**Zoning Ordinance Number 2004-O-43
Approving Planned Development
District General Implementation Plan and
Specific Implementation Plan Zoning for
Outlot 6 Oak Meadow**

ORDINANCE NO. 2004-O-43 000166
APPROVING PLANNED DEVELOPMENT DISTRICT GENERAL
IMPLEMENTATION PLAN AND SPECIFIC IMPLEMENTATION PLAN
FOR OUTLOT 6 OAK MEADOW

GIP/SIP REPORT
NOBEL RIDGE CONDOMINIUM
OUTLOT 6 - OAK MEADOW

NOBEL RIDGE CONDOMINIUMS

SITE MASTER PLAN

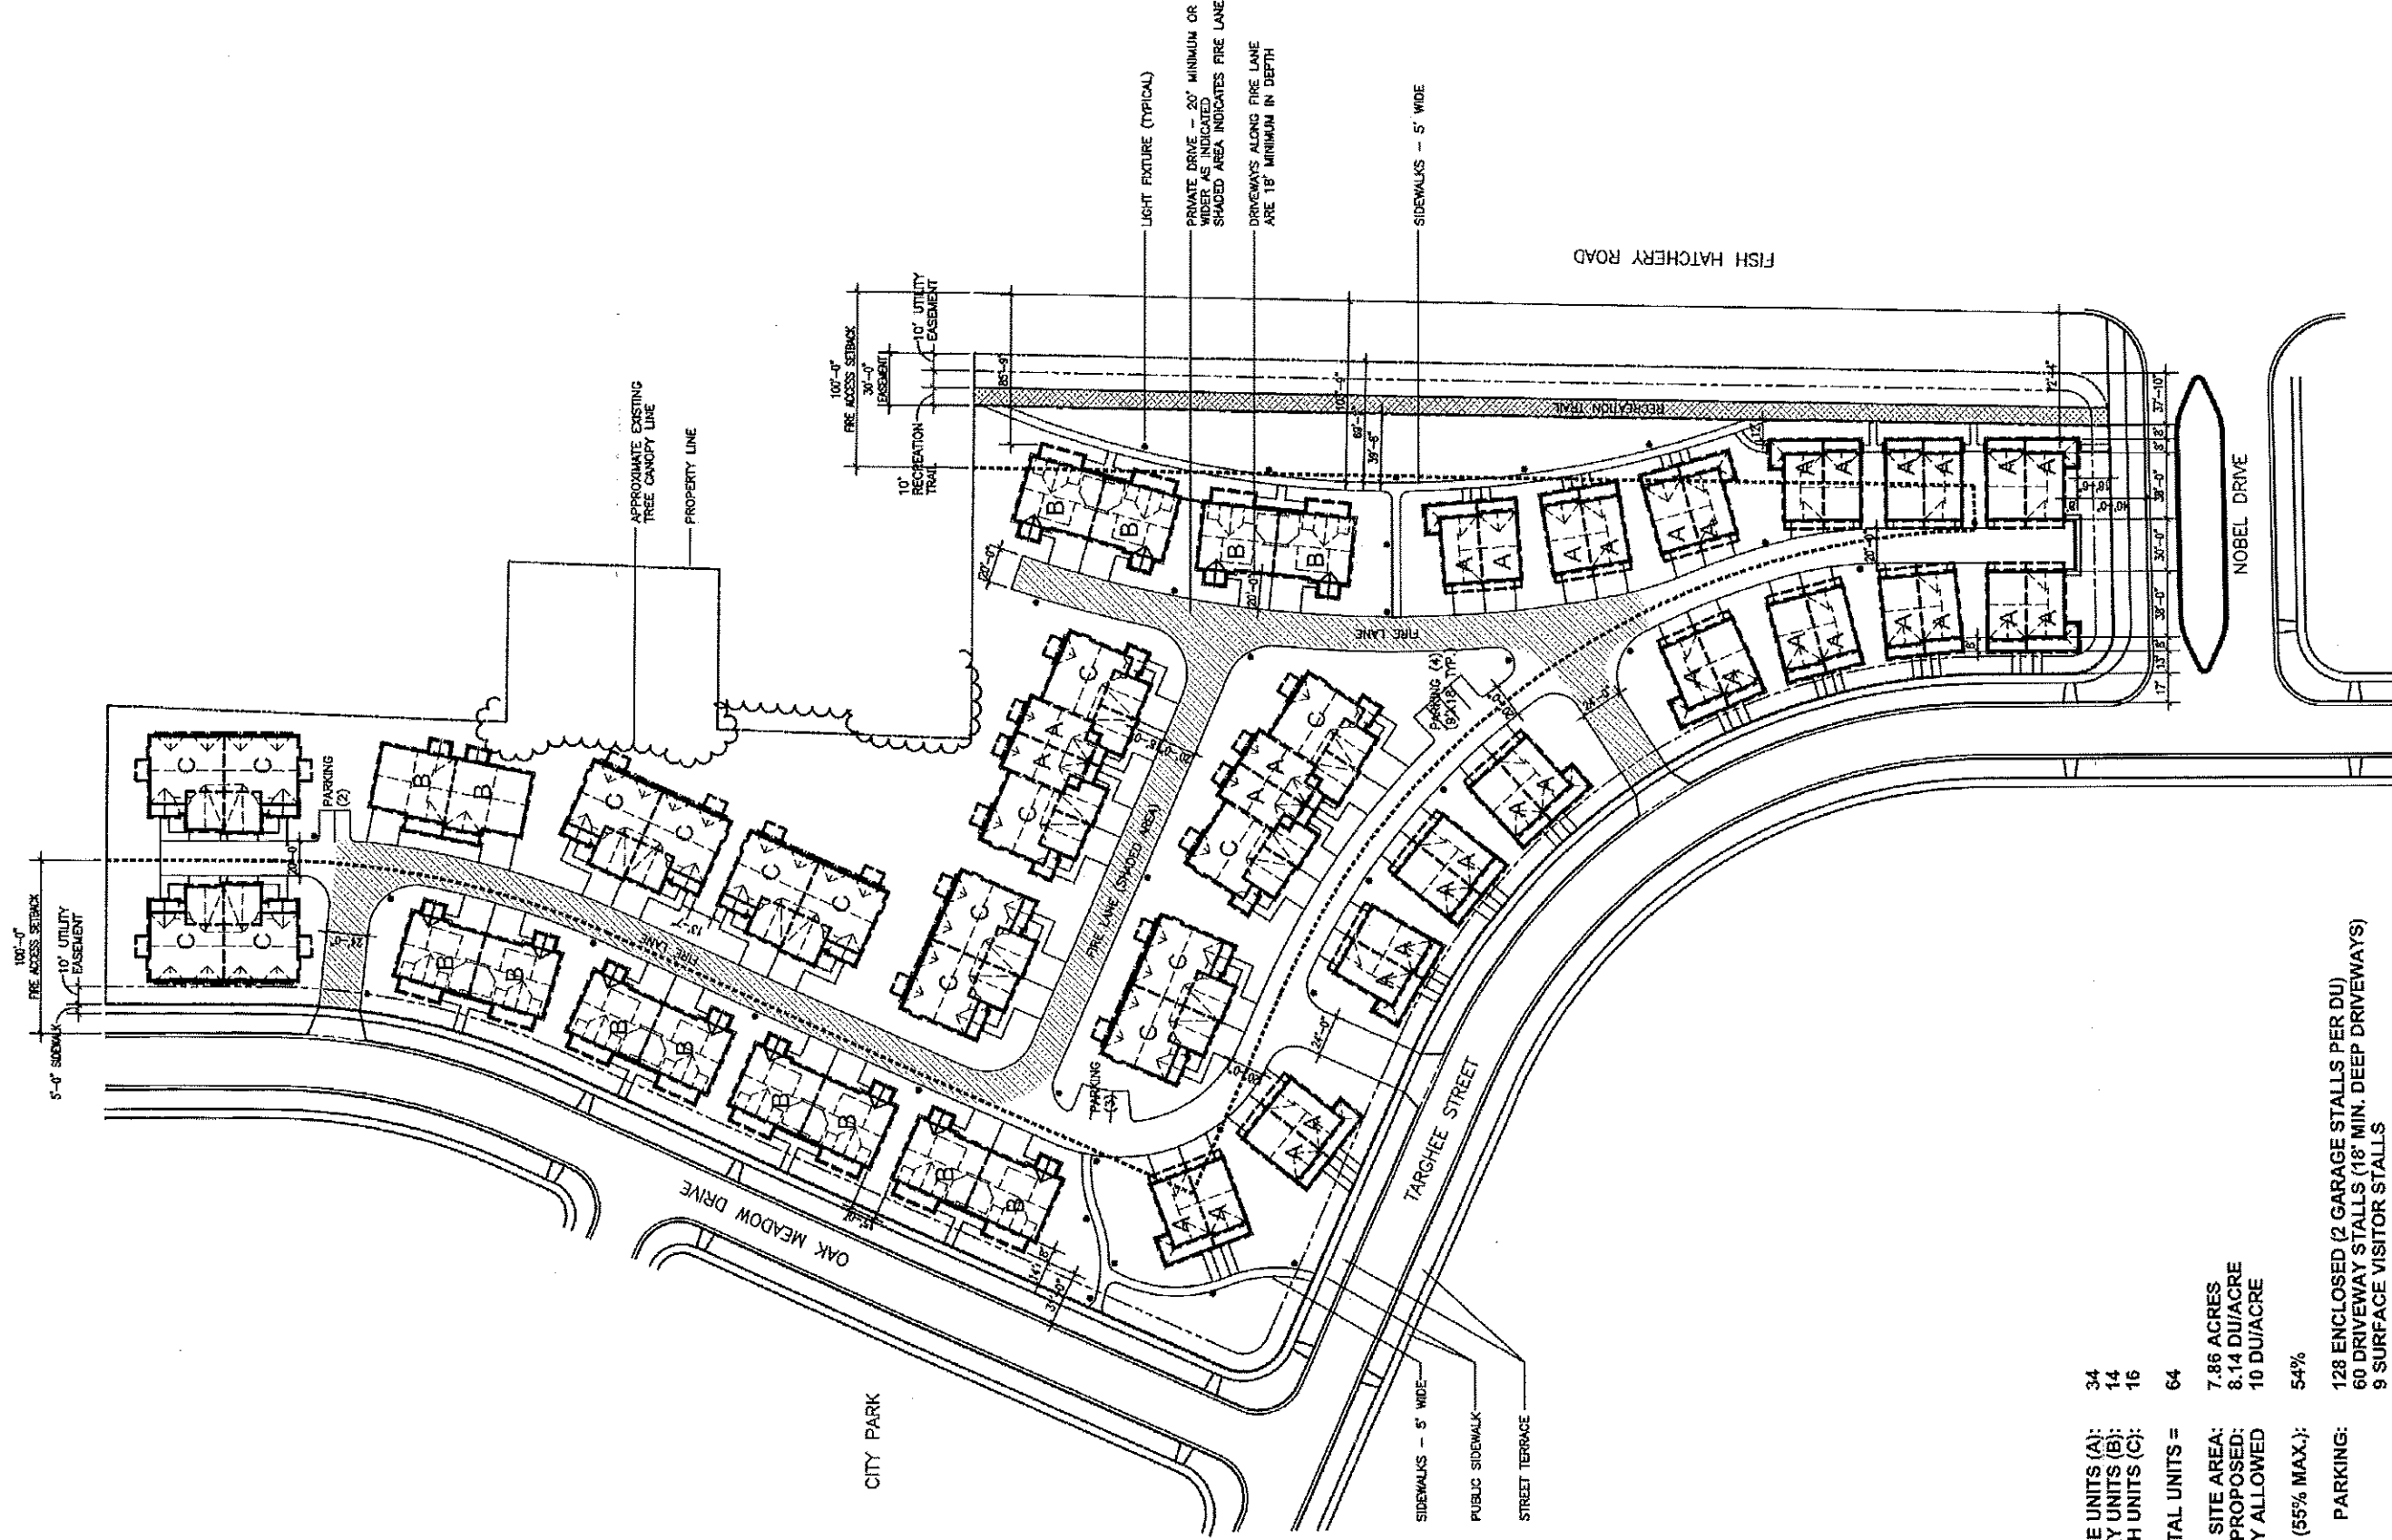
9. Upon satisfaction of above conditions #4, #5, #7, and #8 building permits shall only be available for building #'s 11, 12, 13 and 14. Buildings #'s 1 through 10 shall be allowed permits only after a public improvement agreement for provision of water and sanitary sewer has been executed and the improvements have been installed, and then accepted by the City. Buildings #'s 15 through 27 shall not be permitted until Oak Meadow LLC has completed, and had accepted, the street improvements for Oak Meadow Drive, and the any necessary improvements required for this parcel have been installed by a responsible party and accepted by the City. (Numbers are based on master site plan dated 10/20/2004 by Potter Lawson).

10. Amend the vision triangle on the proposed plat for Nobel and Targhee , or reduce the porch on the south unit of Bldg #7.

As indicated by Paul Woodard's e-mail dated September 16th, the development will have reduced width drives. It could be problematic if a fire truck or even the City's Sewer truck needs to enter the development using the private drives. I have indicated to Mr. Kruser that the FD would prefer the paved cross-section to be a minimum of 20 feet wide. Mr. Kruser indicated that the paved width will be 17 feet with the ribbon curbs making the up rest of the required 20 feet wide drive.

Mr. Kruser did identify the buildings that are clearly beyond 100 feet of the municipal street access for FD apparatus and have been planned for fire lanes, but the 3 - 2 unit condos in the Southeast corner have access issues for the FD. Mr. Kruser has indicated to me that in discussions with Paul Woodard, they have been allowed to increase the width of the recreation trail to the East of the 3 condos.

The FD will accept the 13 foot wide pavement drive for apparatus access on the recreation trail, but must have an overall width of 20 feet, level working area, end to end for the access to the 3 condos. The nearest edge of the Fire Lane shall be no less than 10 feet from the buildings. A fire hydrant is also required at the opening of the Fire Lane at Nobel Drive. As for the rest of the development, appropriate corrections have been made by Mr. Kruser to meet the requirements of the Access for Apparatus Code and shall be held responsible to assure that Code is strictly followed.

TOWNHOUSES ALONG
TARGHEE STREET

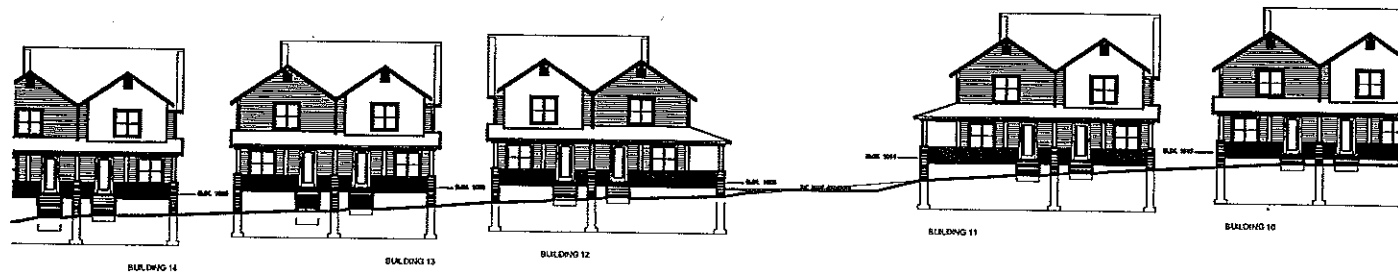
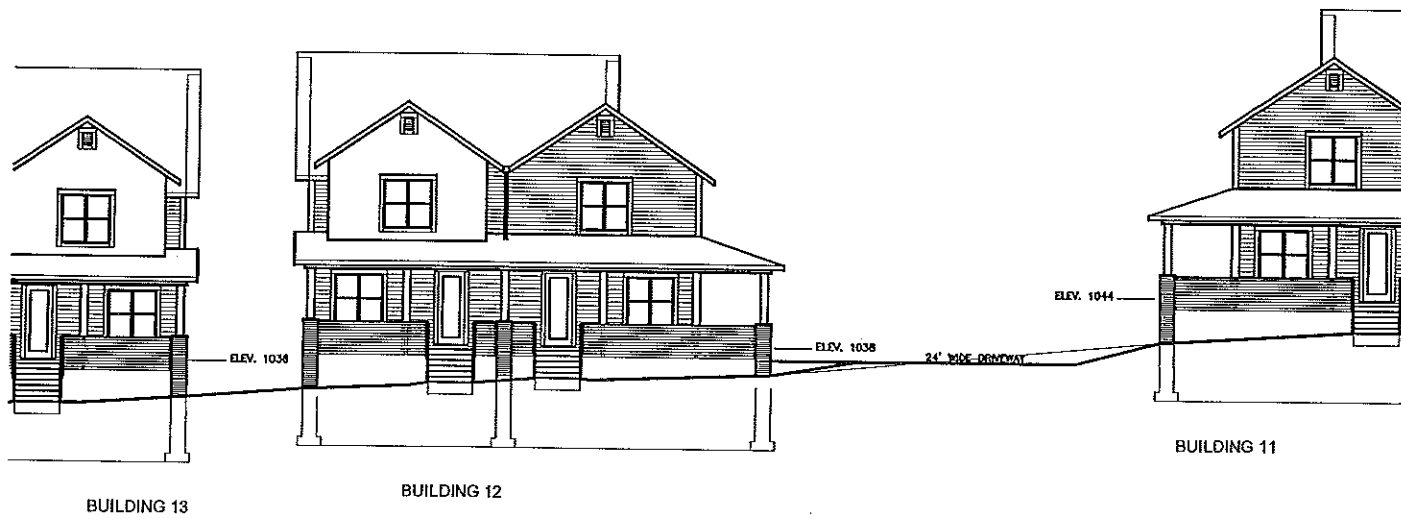
Attached are two supplemental exhibits illustrating what we discussed yesterday. Exhibit 6E shows Targhee Street elevations of buildings #10 through #14 as the street grade drops in elevation. Exhibit 6F shows a typical cross section through building type "AA" (townhouses) at Targee Street. This section and Exhibit 6E show that, at a maximum, we can provide access from public sidewalk to the porch level with 8 risers (7.25" ea. x 8 = 4'-10" rise) and seven treads (12" ea. x 7 = 7'). Our intent is to have a PowerPoint presentation at the 10/5 PC meeting showing how this compares with homes in Middleton Hills and traditional areas such as found in the Monroe Street and West High areas.

TOWNHOUSE UNIT CROSS SECTION @ TARGHEE STREET

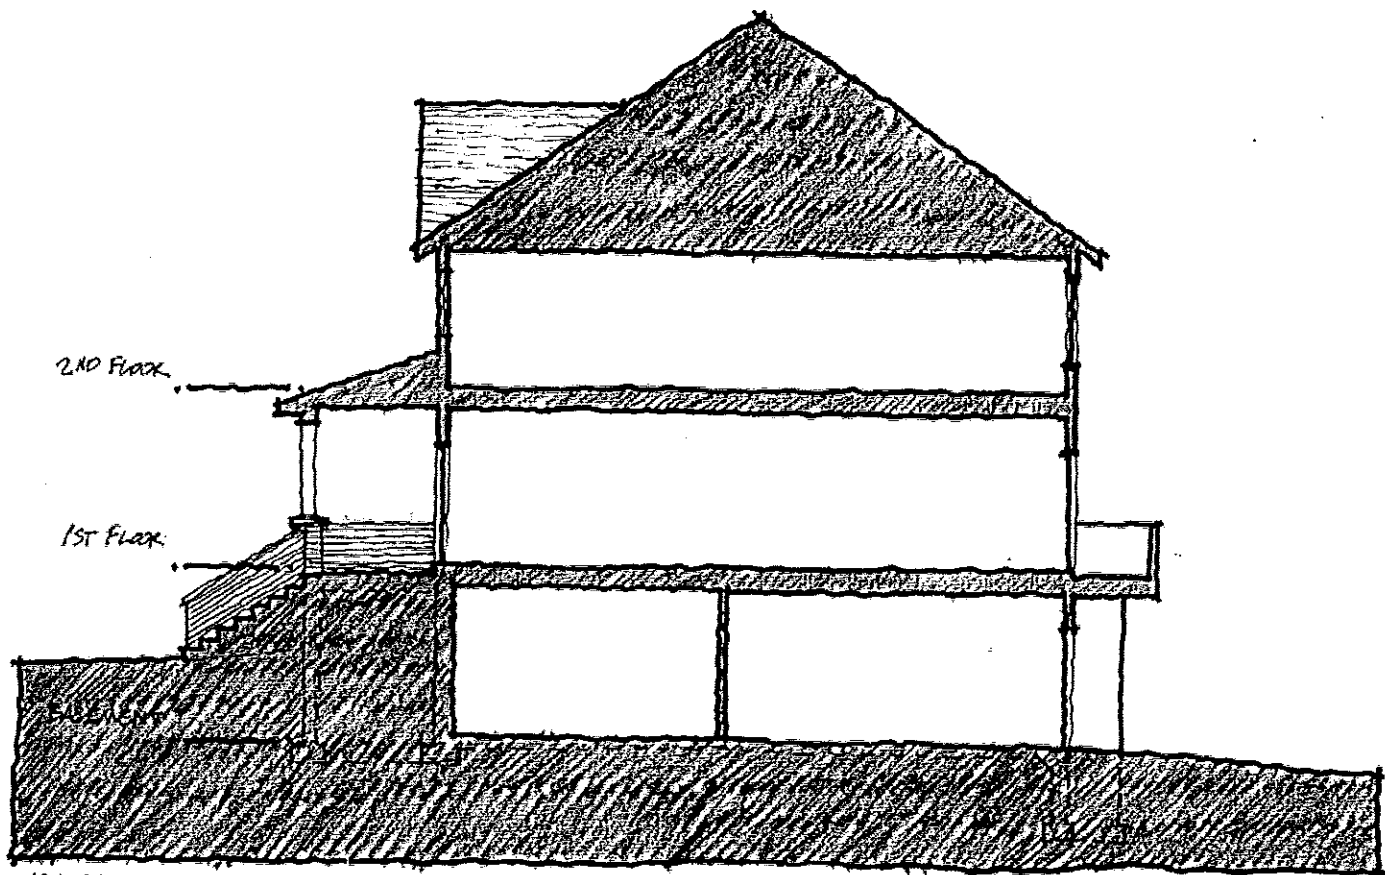
Thanks Mark, but how far do the steps go into the front setback area? Can you provide a detail site plan showing that? Are the steps on foundation or are they floating, floating would be better from setback standpoint.

Buildings along Targhee Street are 12'-6" from the property line (minimum). This dimension is from the porch (not the actual unit) to the property line. The sidewalk is another approximate 6" outside of the property line. The actual dwelling unit is another 8' back (20'-6" to property line, 21' to sidewalk). The porch steps will be floating poured concrete projecting out 7' max. from the porch. Thus, the steps will be 5'-6" from the property line (6' from sidewalk) or greater. Additionally, there is a generous terrace measuring 17 feet from street curb to property line.

As a comparison, Middleton Hills has a "Build-to" line of eight feet for most lots. 25% of the residence must be up to that 8' setback, or "build-to" line. Porches can then project into that right up to the property line.

Please see attached exhibit showing terrace and front setback dimensions.

TYPE "AA" UNIT
CROSS SECTION AT TARGHEE STREET

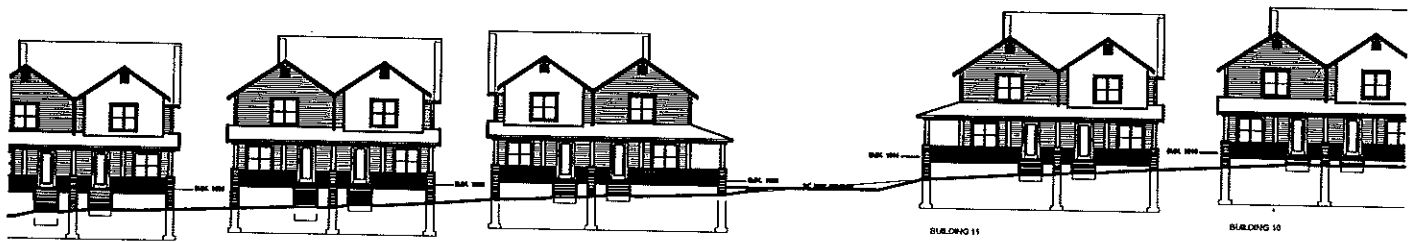
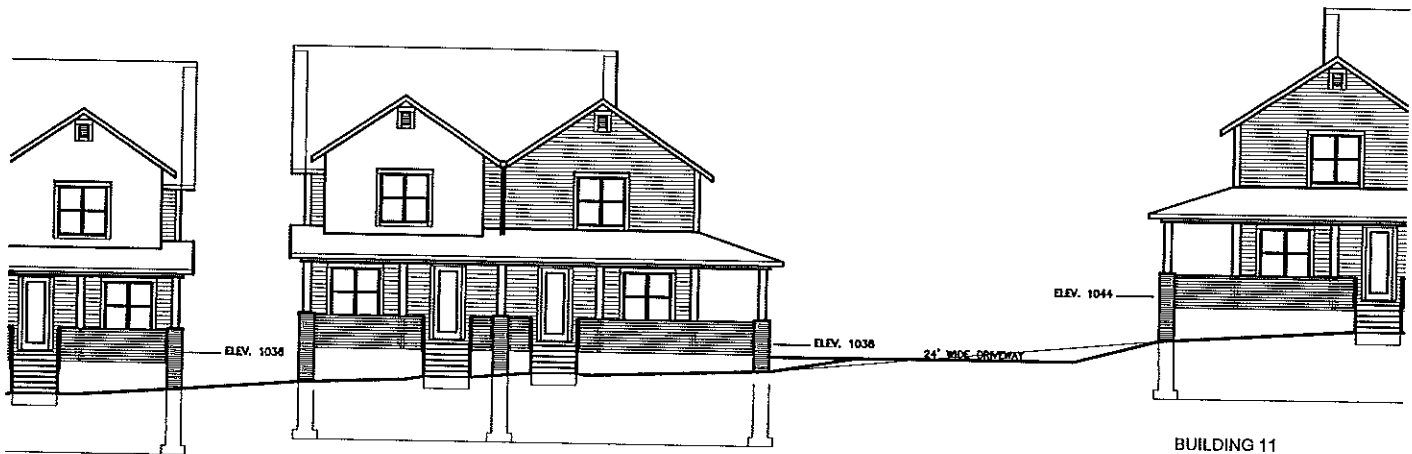
Attached are two supplemental exhibits illustrating what we discussed yesterday. Exhibit 6E shows Targhee Street elevations of buildings #10 through #14 as the street grade drops in elevation. Exhibit 6F shows a typical cross section through building type "AA" (townhouses) at Targhee Street. This section and Exhibit 6E show that, at a maximum, we can provide access from public sidewalk to the porch level with 8 risers (7.25" ea. x 8 = 4'-10" rise) and seven treads (12" ea. x 7 = 7'). Our intent is to have a
